Team Update 01

Figure 6-1 MATCH setup

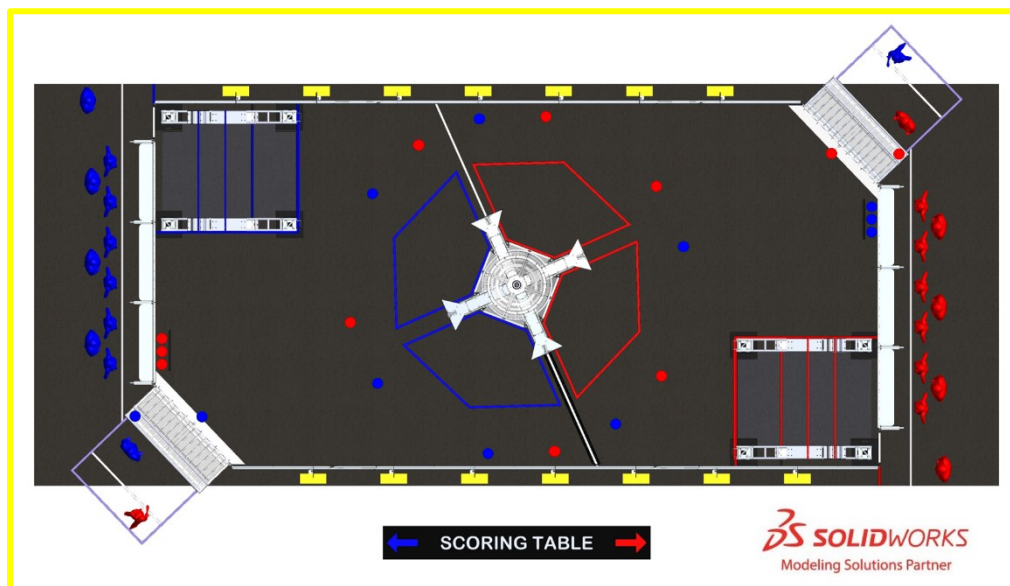
Figure 6-1 is updated to correct the starting location for CARGO not staged in ROBOTS.
